MHTN
ARCHITECTS

Addendum No. 02

Project Name: **SJSD Albert R. Lyman Middle School**

Addendum No. 02 to the Construction Contract for the above-referenced project:

EXISTING
REFERENCE
ELEVATIONS

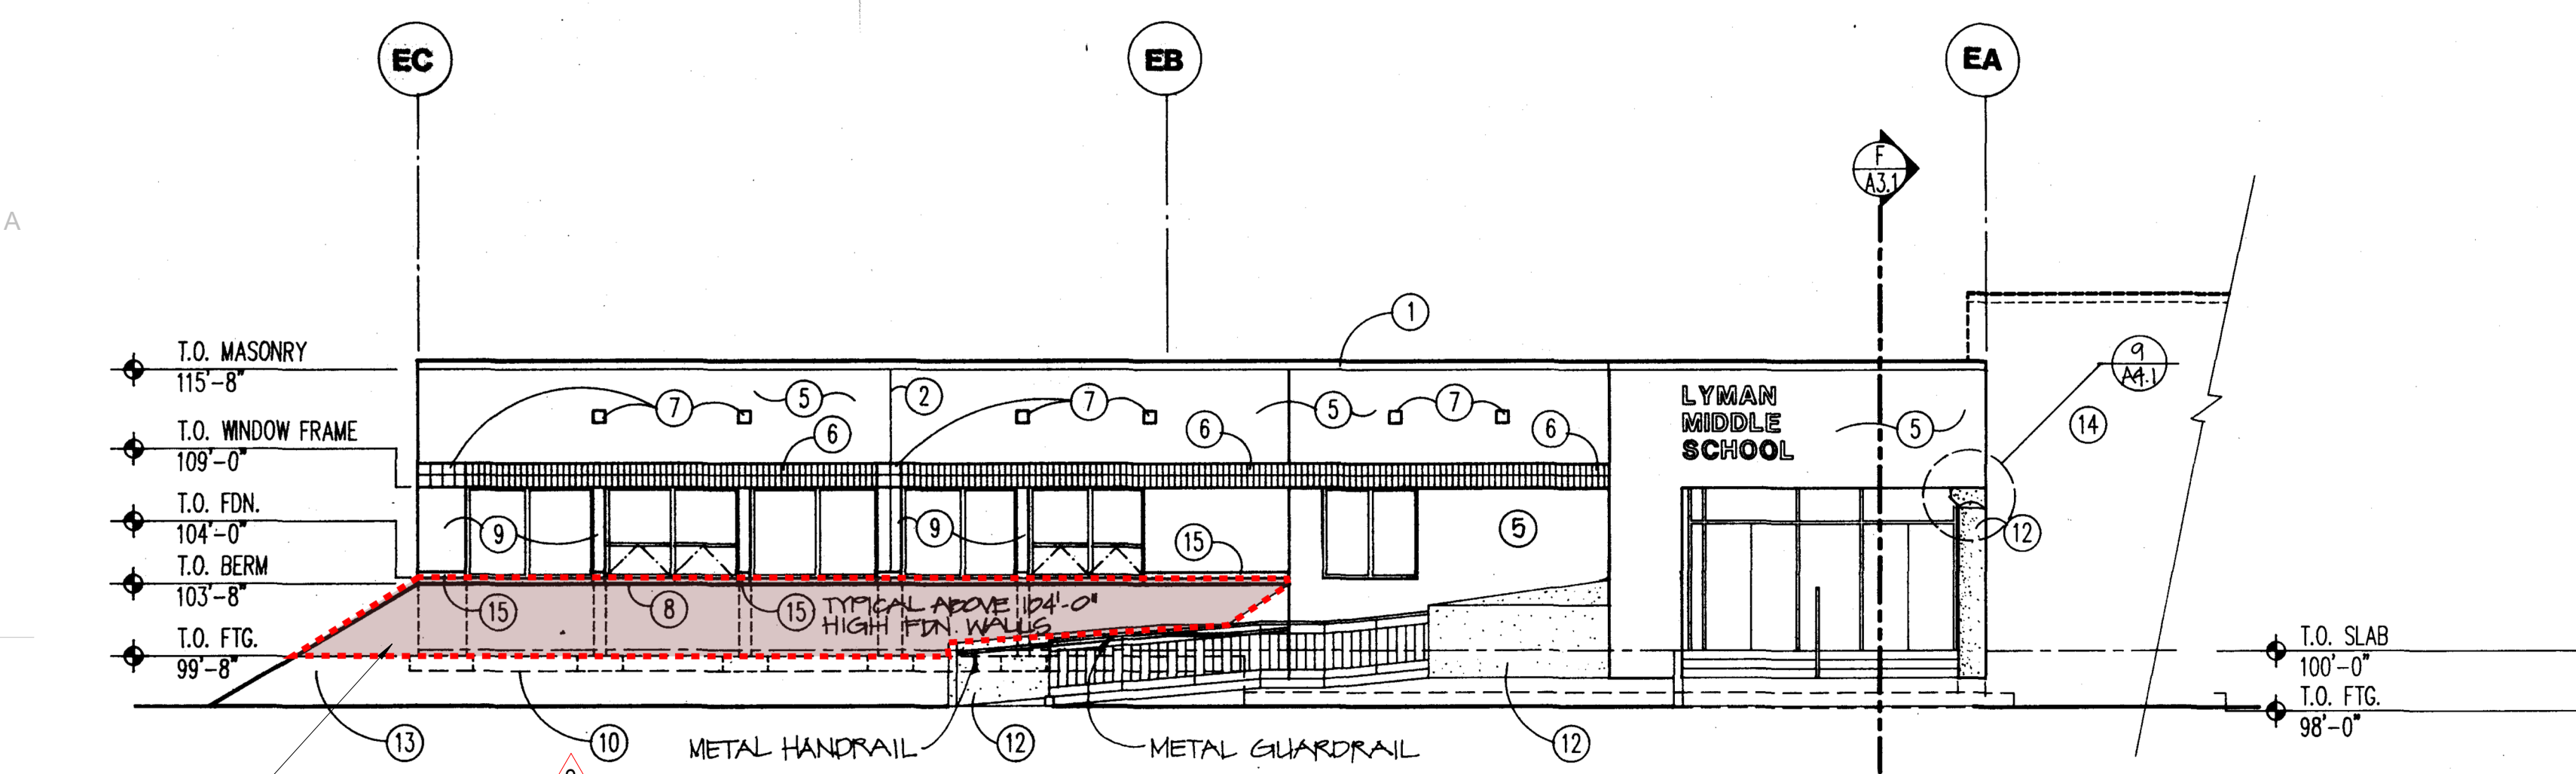
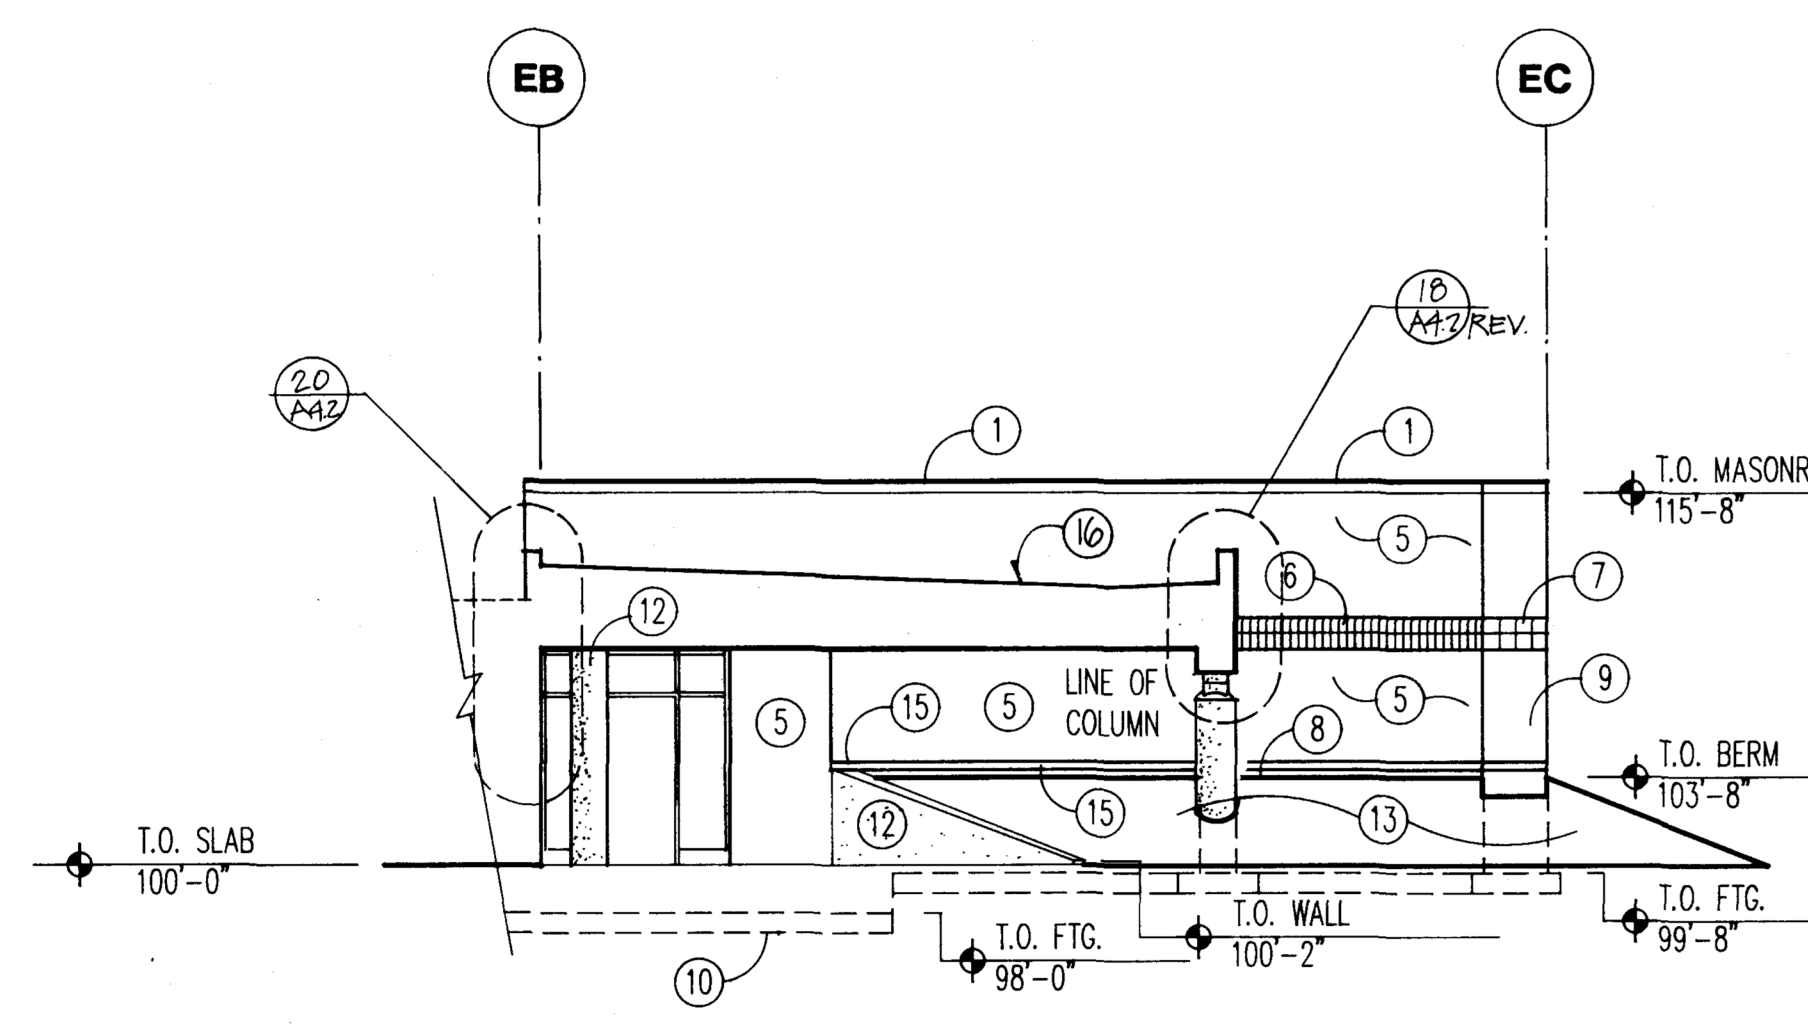
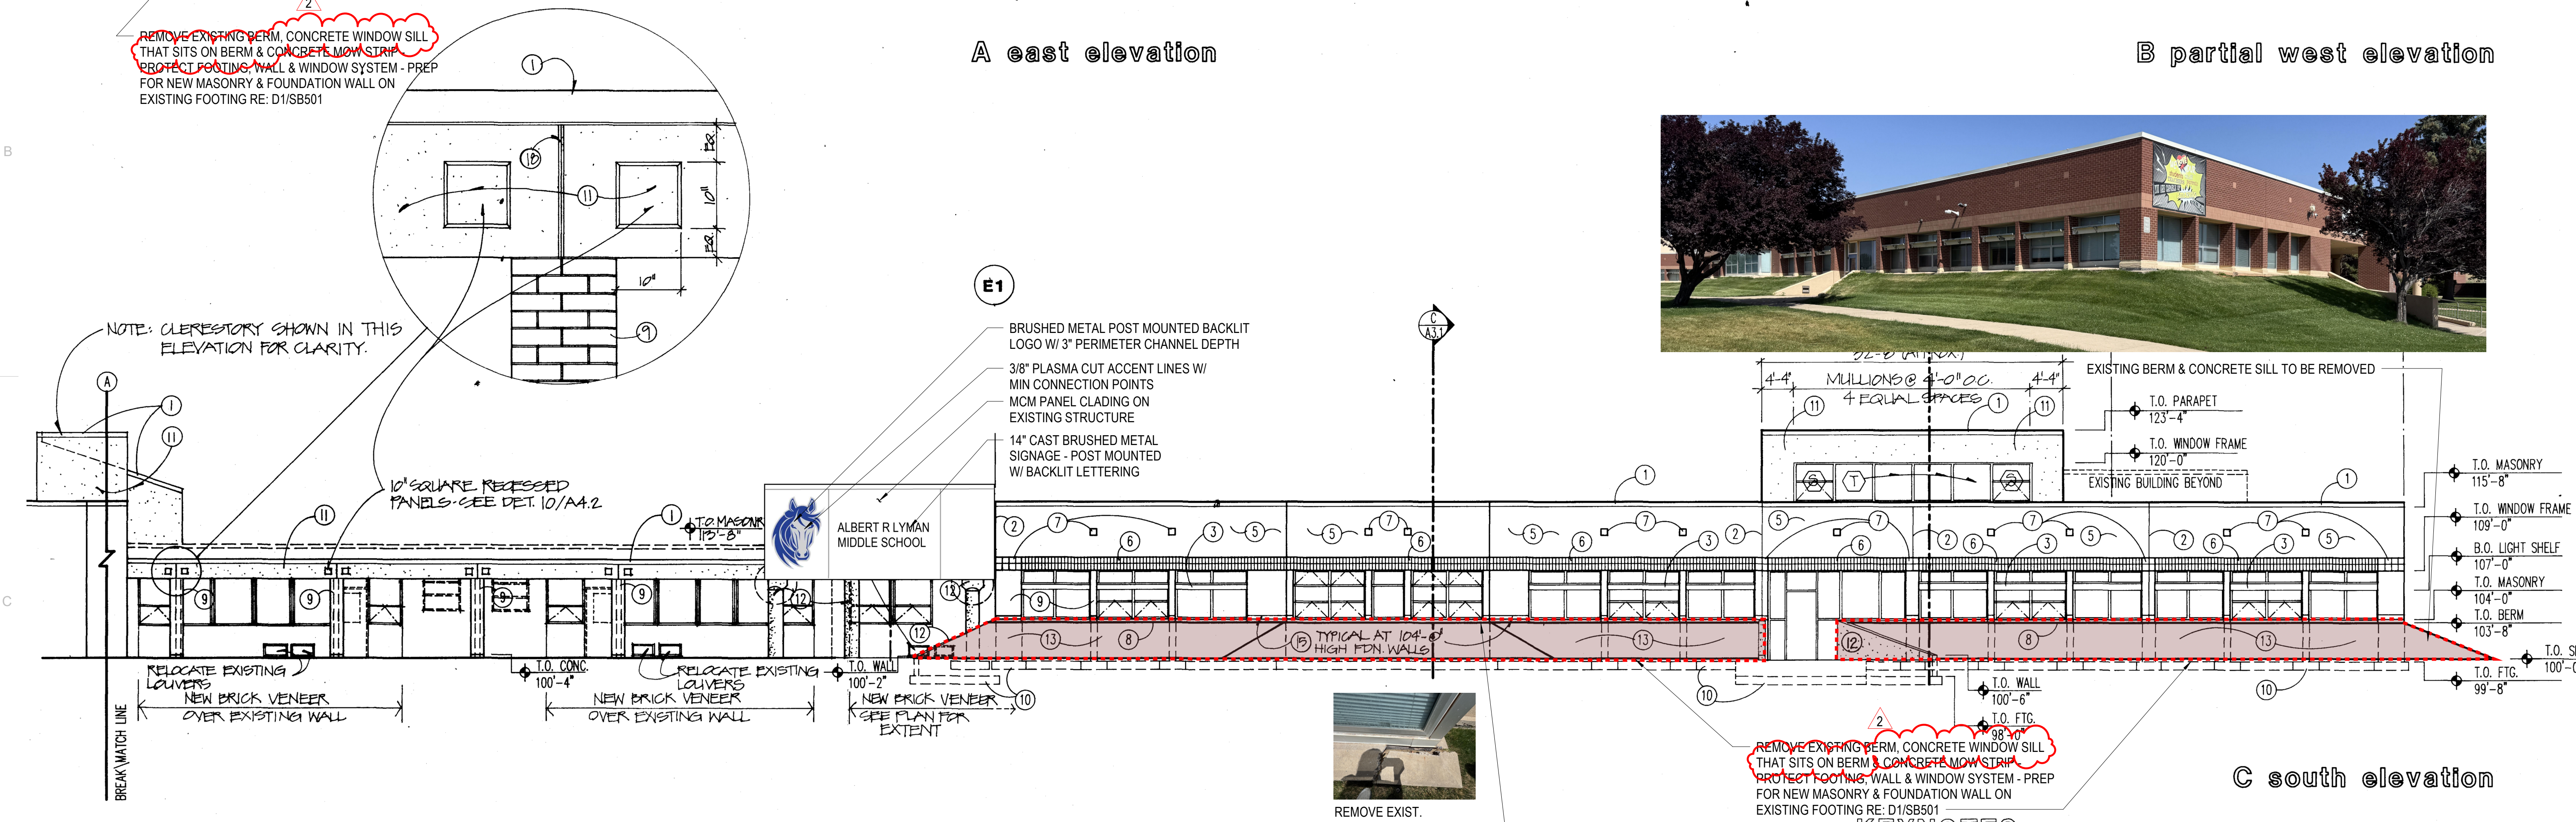
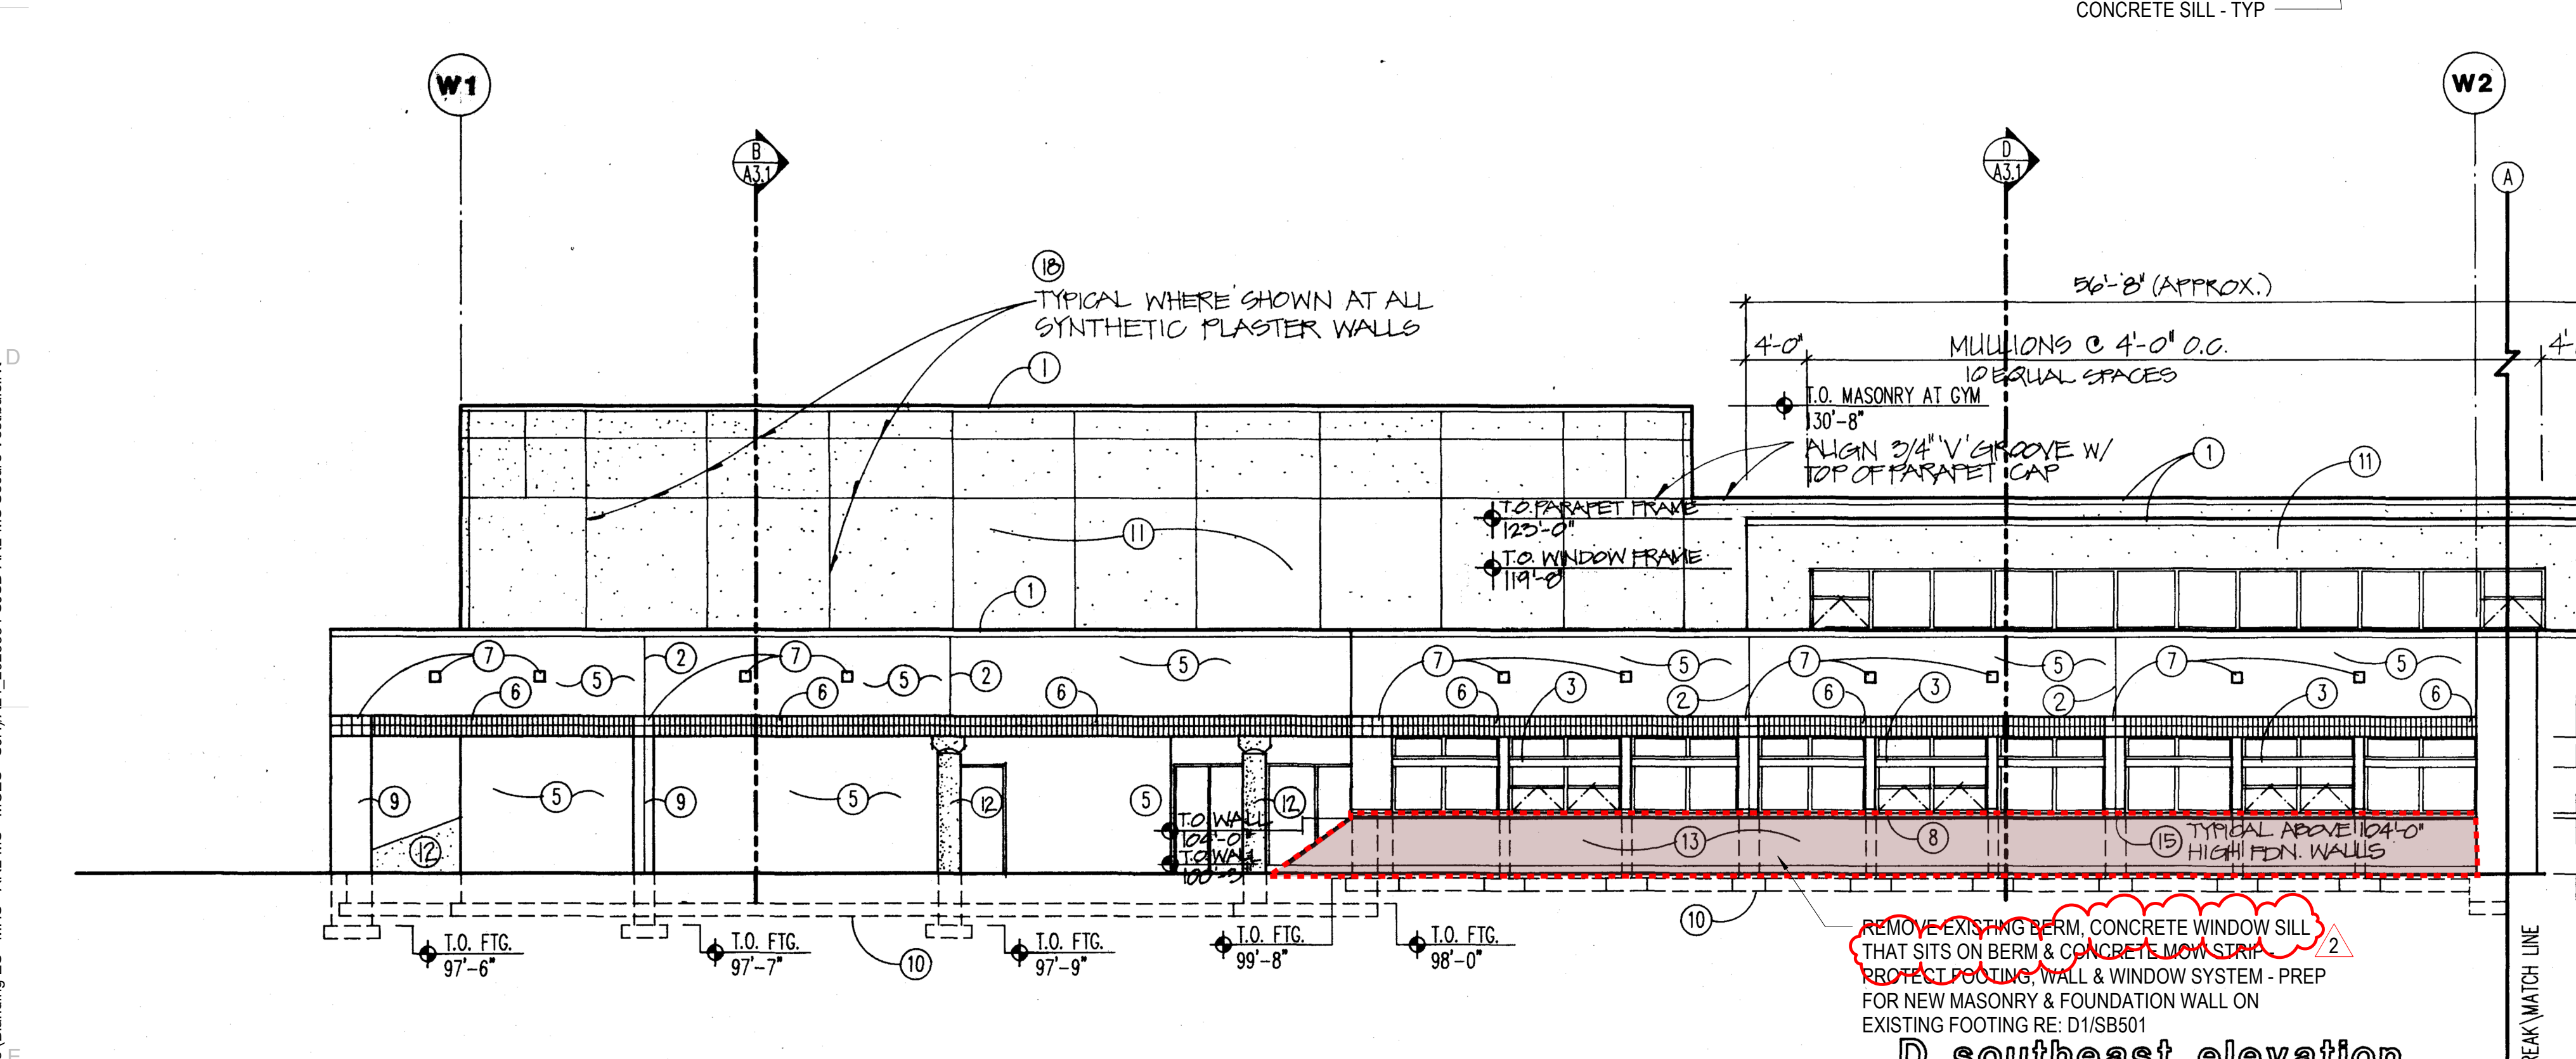
1. Added roof plan keynotes to identify size and location of roof hatch.
- A2.6 Sheet A201 – Existing Reference Elevations
1. Modified sheet note to include removal of concrete window sill that sits on berm.

E5 WORKROOM - S
SCALE: 1/4" = 1'-0"

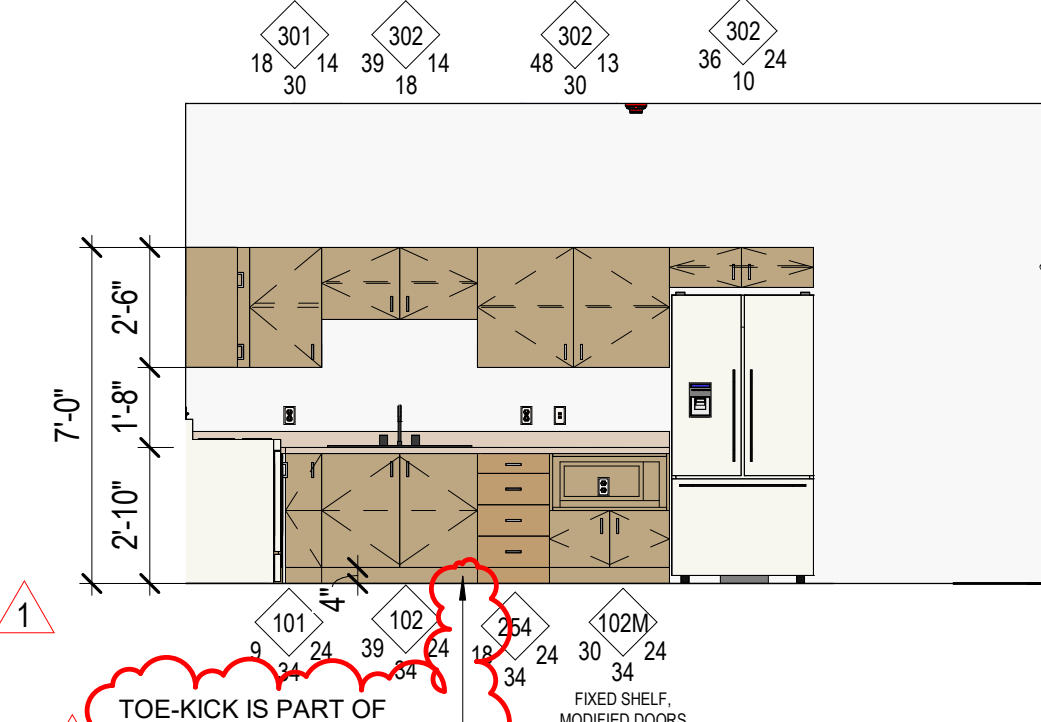
- A2.7 Sheet A410 and A411 – Interior Elevations
1. Add note on E5/A410 and A4/A411 to provide integral toe kick in sink cabinet door for ADA access.
- A2.8 Sheet A600 – Door Schedule & Details
